SITE PLAN - ADD ALTERNATES

FM 270 PUBLIC BOAT RAMP
2913 MARINER DRIVE
LEAGUE CITY, TEXAS 77573

ADDENDUM 01 05-28-2026

SITE PLAN

ENLARGED SITE PLAN - ADD ALTERNATES

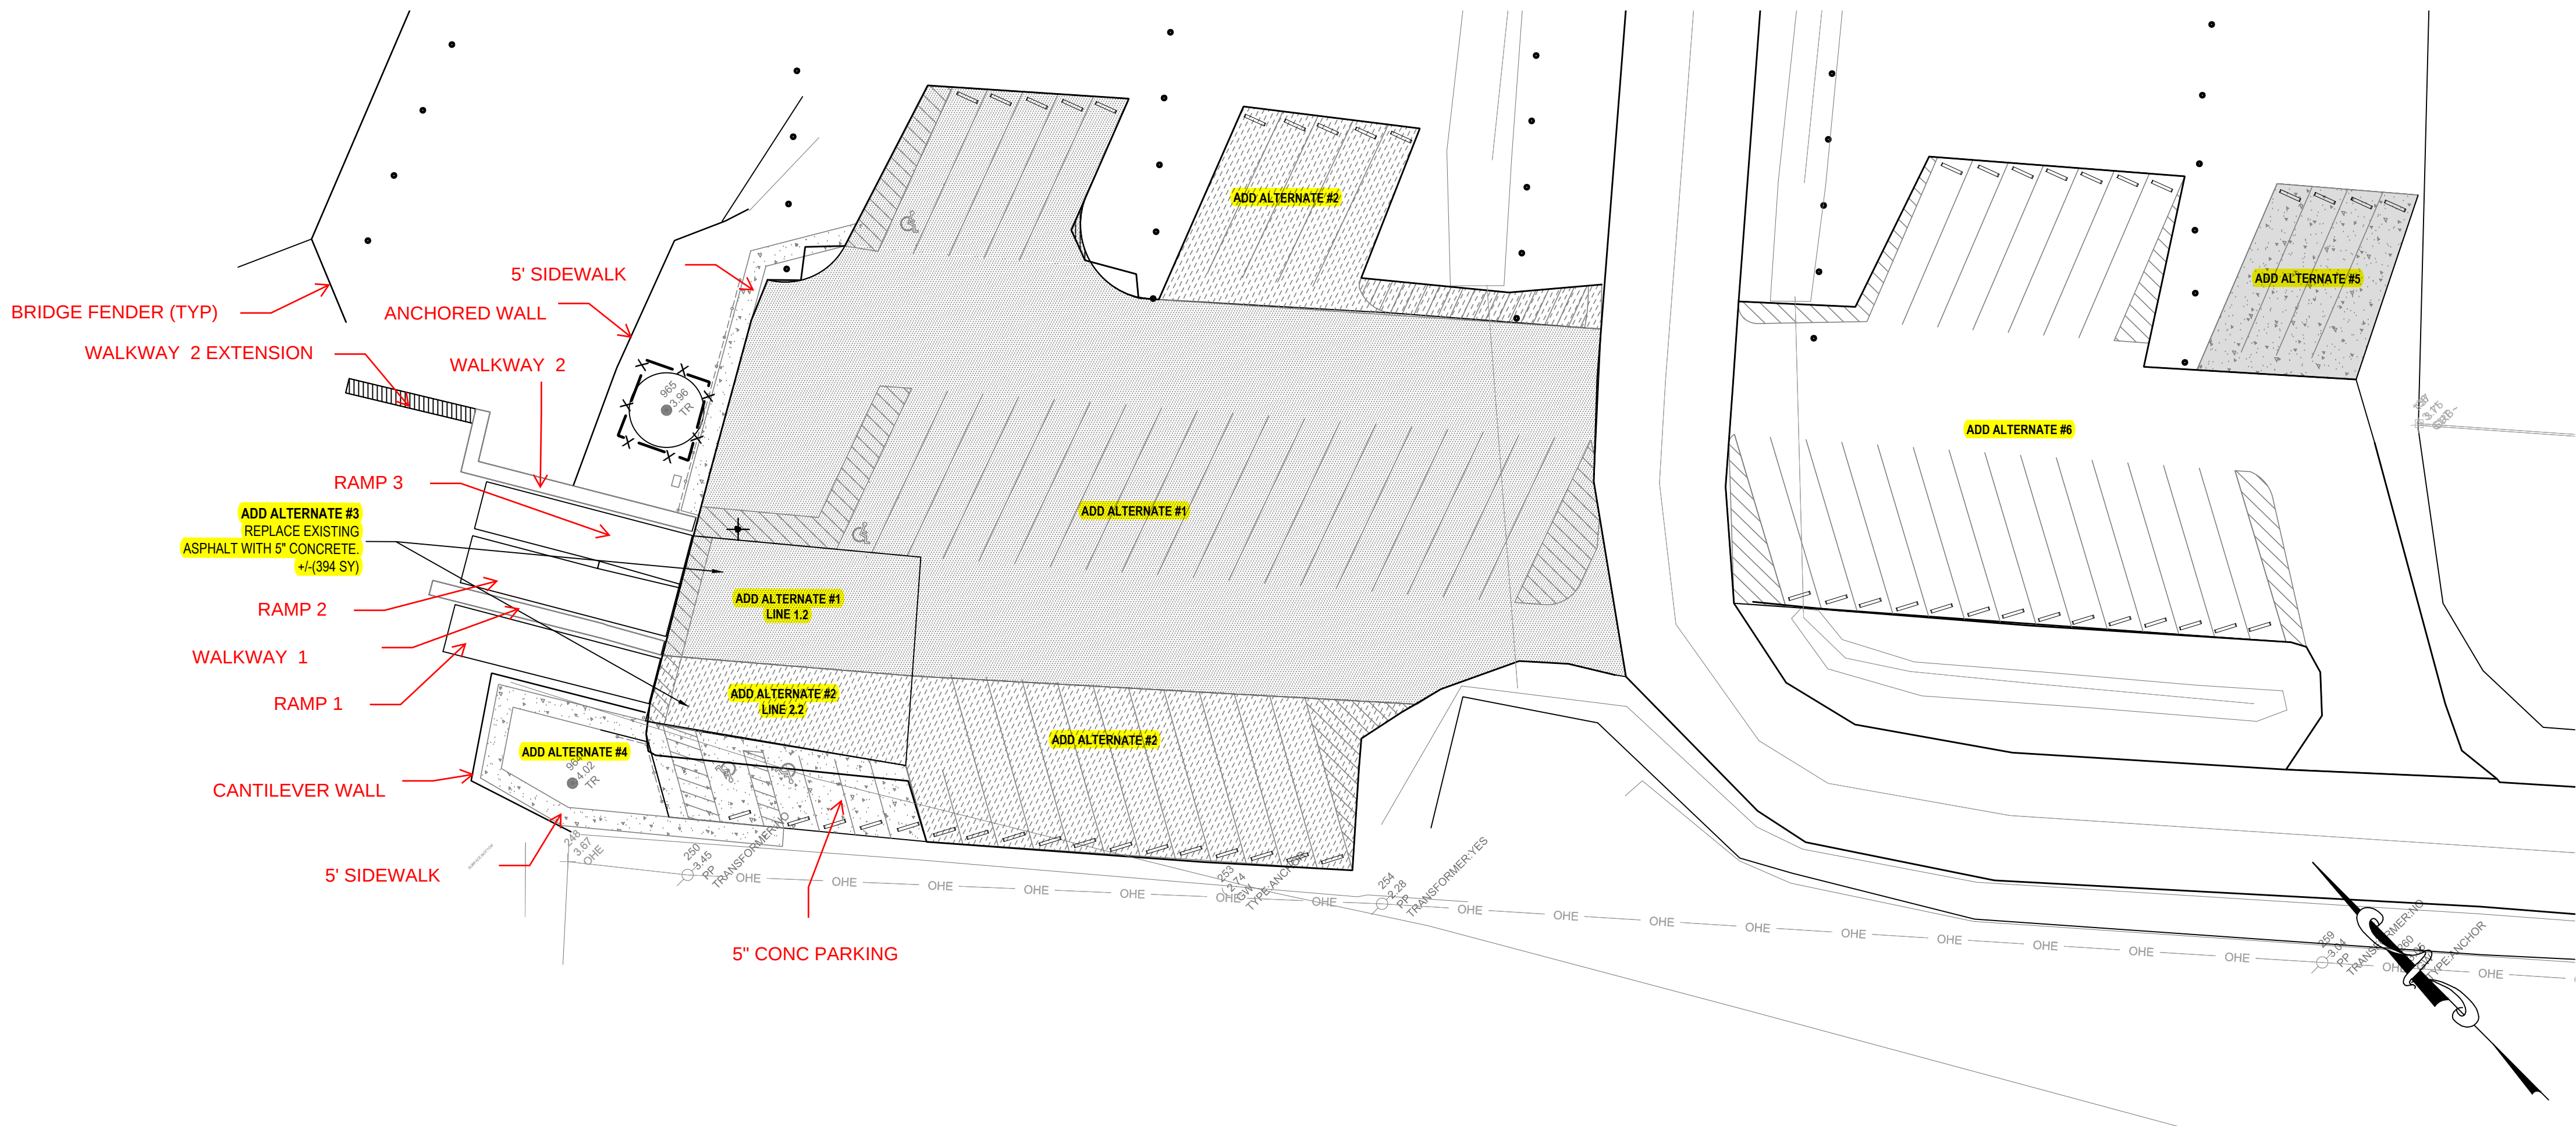
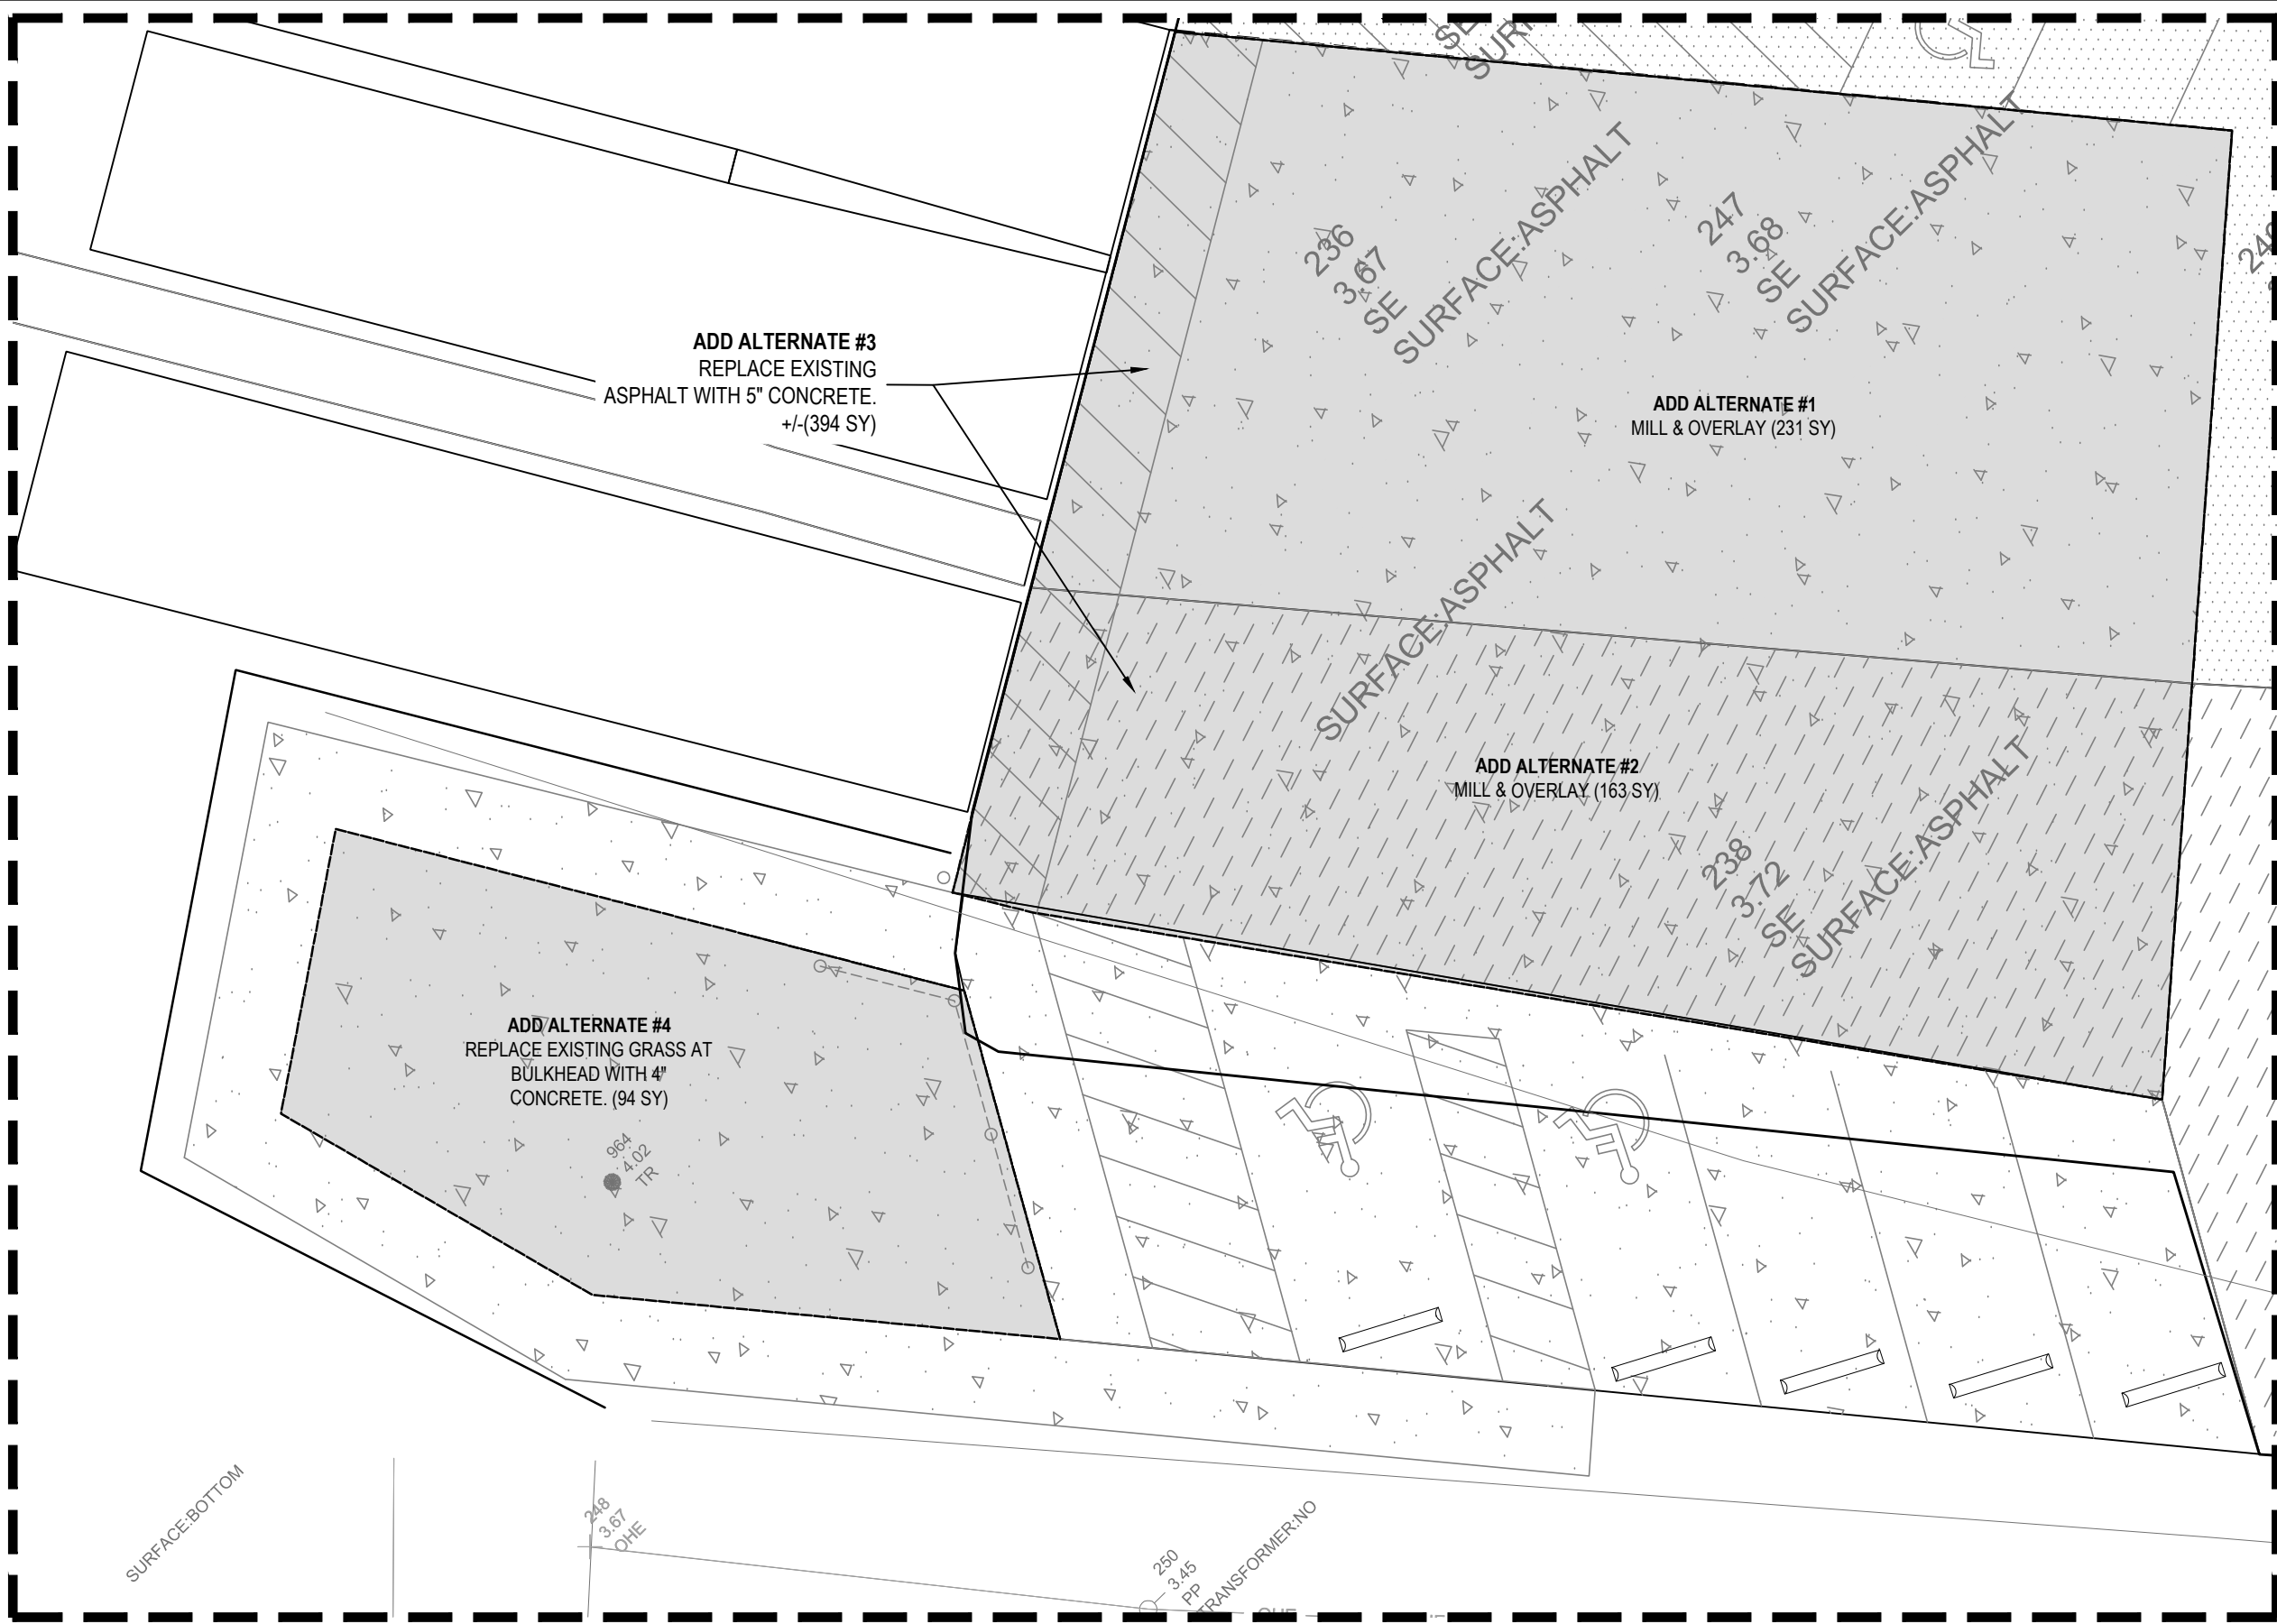
ADD ALTERNATE 1 - PARKING LOT A ASPHALT MILL & OVERLAY
IN LIEU OF REMOVING STRIPING, MILL EXISTING 2" ASPHALT AND OVERLAY PARKING LOT, (2,852 SY).
IN LIEU OF REMOVING STRIPING, MILL EXISTING 2" ASPHALT AND OVERLAY BEHIND BOAT RAMP, (231 SY).
CREDIT FOR BASE BID - CLEANING PAVING AND STRIPING REMOVAL

ADD ALTERNATE 2 - PARKING LOT A ASPHALT MILL & OVERLAY
IN LIEU OF REMOVING STRIPING, MILL EXISTING 2" ASPHALT AND OVERLAY PARKING LOT, (959 SY).
IN LIEU OF REMOVING STRIPING, MILL EXISTING 2" ASPHALT AND OVERLAY BEHIND BOAT RAMP, (163 SY).
CREDIT FOR BASE BID - CLEANING PAVING AND STRIPING REMOVAL

ADD ALTERNATE 3 - PARKING LOT A CONCRETE PAVING
IN LIEU OF REMOVING STRIPING, SAW CUT AND REMOVE EXISTING ASPHALT AND BASE TO +/-12", GRADE TO DRAIN, (131 CY).
INSTALL BASE AND 5" CONCRETE PAVING, (394 SY).
CREDIT FOR BASE BID - CLEANING PAVING AND STRIPING REMOVAL

ADD ALTERNATE 4 - BULKHEAD
IN LIEU OF HYDROSEEDING, EXCAVATE AND REMOVE EXISTING SOILS TO 12", GRADE TO DRAIN, (31 CY).
INSTALL BASE AND 4" CONCRETE PAVING, (94 SY).
CREDIT FOR BASE BID - HYDROSEEDING

ADD ALTERNATE 5 - PARKING LOT B CONCRETE PAVING
EXCAVATE AND REMOVE EXISTING SOILS TO 12". GRADE TO DRAIN, (76 CY).
INSTALL BASE AND 5" CONCRETE PAVING, (229 SY).
INSTALL STRIPING AND (4) CONCRETE WHEEL STOPS

ADD ALTERNATE 6 - PARKING LOT B
STRIPE, AND INSTALL (21) NEW CONCRETE WHEEL STOPS.
